SUBJECT: VOGTLE ELECTRIC GENERATING PLANT ESP SITE - ISSUANCE OF EXIGENT  
AMENDMENT RE: REQUEST FOR CHANGES TO THE SITE SAFETY  
ANALYSIS REPORT

Amendment No. 1  
Early Site Permit No. ESP-004

SAFETY EVALUATION BY THE OFFICE OF NEW REACTORS

RELATED TO AMENDMENT NO. 1 TO EARLY SITE PERMIT NO. ESP-004

Figure 1. Nomenclature of Vogle Site Subsurface Strata (from SSAR Figure 2.5.1-8)

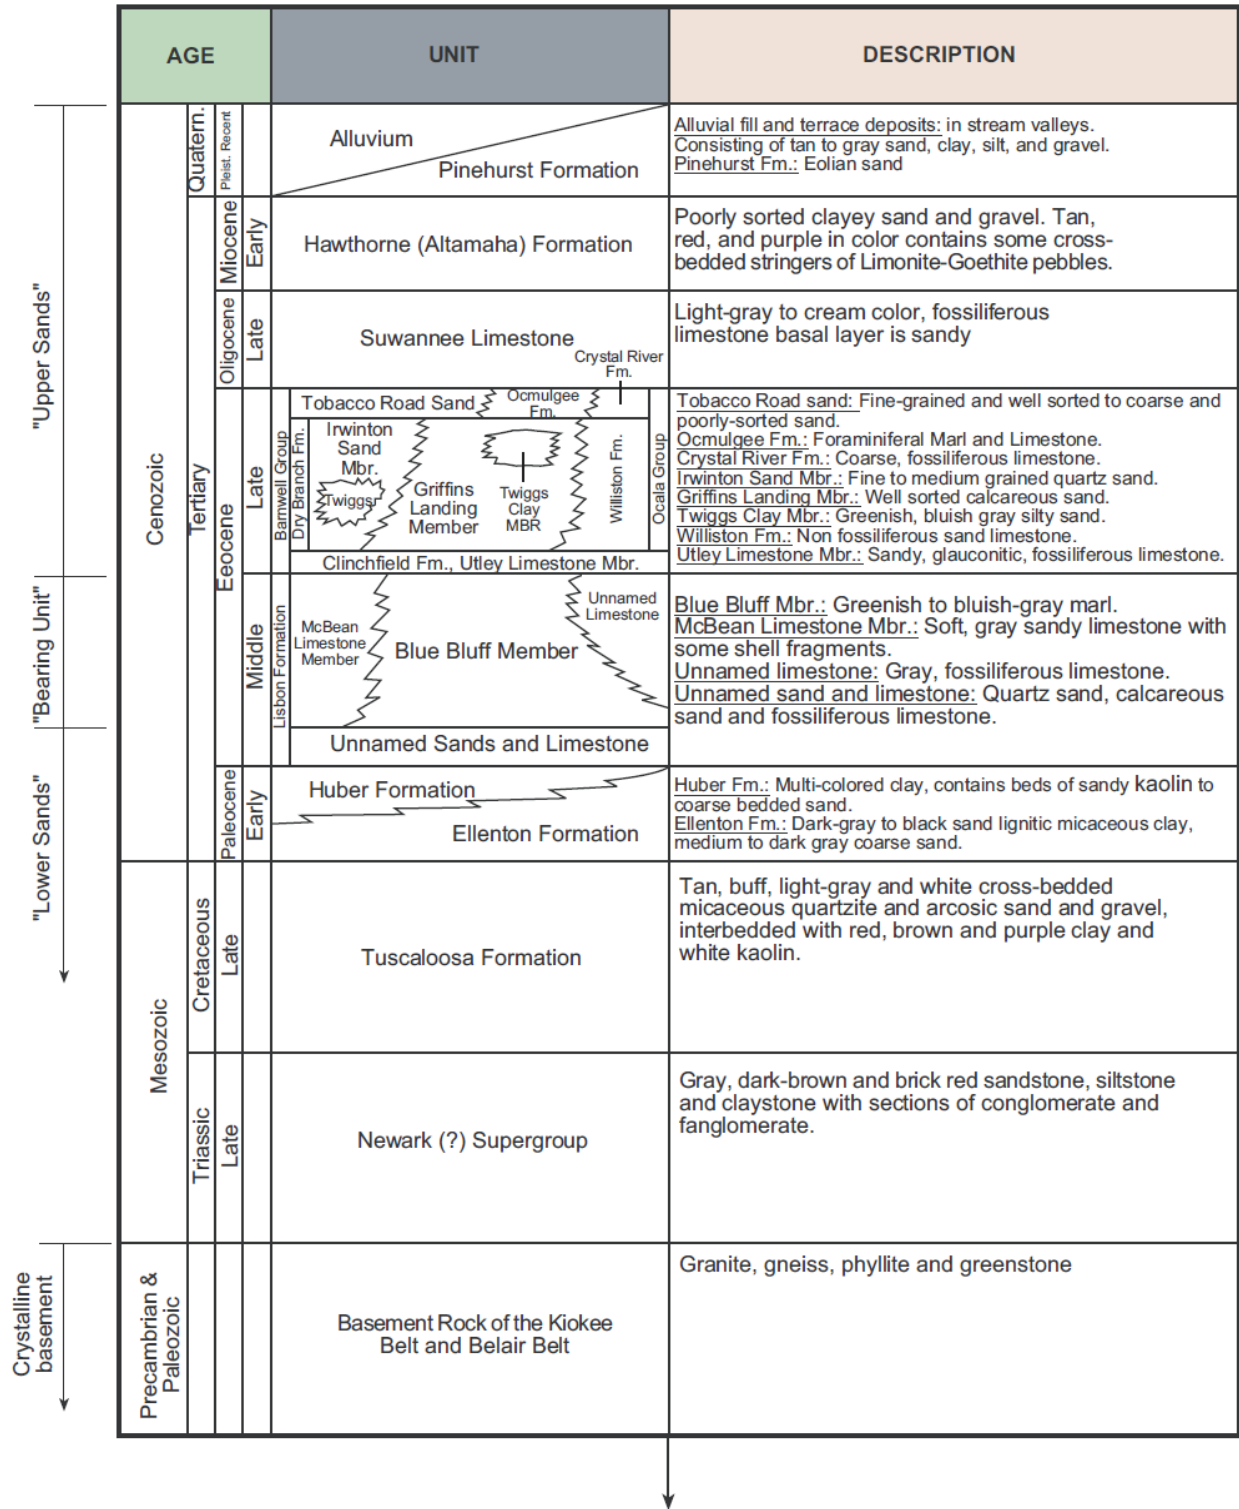
In support of its ESP and COL applications, the applicant conducted field and laboratory tests for selected subsurface layers that covered most of the site. These tests provided sufficient data to determine the properties of the subsurface materials of the upper portion of the Barnwell Group within the Upper Sand stratum occurring within the EAB. As defined by the applicant in SSAR Section 2.5.4 and shown in SER Figure 1 (modified from SSAR Figure 2.5.1-8), the Upper Sand stratum includes geologic formations of the Barnwell Group, as well as several other formations.

It is critical that the geological characteristics of the LSA proposed borrow areas be similar to those characteristics specified in the ESP SSAR and approved by the NRC to confirm that the soil in the proposed areas will have the same, or similar, material and engineering properties as that in the areas previously specified in the SSAR. Because spatial variability of the subsurface material is expected, and may be significant even over very short distances, if the geological characteristics of the proposed borrow areas are not the same as the three previously defined borrow areas, then different types of soil (i.e., soil with different mineral composition and material properties) may exist in the new borrow areas. Even if a different type of soil could be qualified as Category 1 and 2 backfill material based on grain size distribution, compaction and all other static engineering properties, the dynamic properties, especially the soil degradation properties, may be significantly different from that of the backfill soil obtained from the SSAR-specified borrow areas. Since all backfill soil will be taken from formations comprising the upper portion of the Barnwell Group that occur within the Upper Sand Stratum as defined in the SSAR, the staff focused the technical evaluation on determining whether or not these Barnwell Group formations extend across the site and exhibit consistent geological characteristics.

Based on the descriptions in SSAR section 2.5.1.2.3.2 and additional information provided in Attachment 2 to the letter of April 28, 2010, "Geological Assessment – Extent and Distribution of Barnwell Sediments at the VEGP Site," the Barnwell Group consists of the Clinchfield (including the basal Utley Limestone member) and Dry Branch Formations and the Tobacco Road Sand. The upper part of the Barnwell Group consists predominantly of quartz sands, silty sands, and clayey sands with occasional clay seams, soft zones, and shell zones. The quartz sands range from fine to coarse grained and are moist and dense. Soil color in the upper portion of the Barnwell Group formations, predominantly red with zones of yellow, orange, lavender, and purple, is imparted by clay coatings on the sand grains of the formations. Sands in the upper part of the Barnwell Group were identified by the applicant as a candidate for Category 1 and 2 backfill soil. The applicant did not include the lower portion of the Barnwell Group as a potential backfill source because of lithologic variations. Based on the previous site investigations for VEGP Units 1 and 2 and the site investigations conducted for the Units 3 and 4 ESP and COL applications, as well as information provided in U.S. Geological Survey Professional Publication 1603 (USGS, 2001), the applicant stated that the Barnwell Group ranges in thickness from slightly less than 30.5 m (100 ft) north of the site to greater than 61 m (200 ft) south of the site.

In summary, the staff agrees that, with some variation from area to area, the geological characteristics of the upper portion of the Barnwell Group within the Upper Sand stratum are consistent with the description of the Barnwell Group sediments across the site, and the upper portion of the Barnwell Group of the Upper Sand stratum contains the same type of sand as that which was previously approved for use as Category I and II backfill material.
